MIL-A-8591H AMENDMENT 1 30 June 1994

AIRBORNE STORES, SUSPENSION EQUIPMENT AND AIRCRAFT-STORE INTERFACE (CARRIAGE PHASE); GENERAL DESIGN CRITERIA FOR

This amendment forms a part of MIL-A-8591H, dated 23 March 1990, and is approved for use by all Departments and Agencies of the Department of Defense.

FIGURE 12. Location of connector on rail launched store.

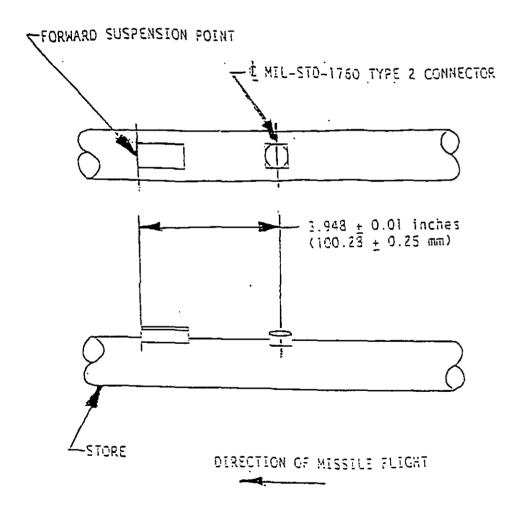
- b. The Type 2 connector specified in MIL-STD-1760 is shown on Figures 4, 5, and 6 for blind mate eject launch applications and Figure 12 for rail launch applications.
- c. 5-pin connector used for rocket launchers and dispenser type stores.
  - d. Connector for electrical fuze."

Add Figure 12 as shown:
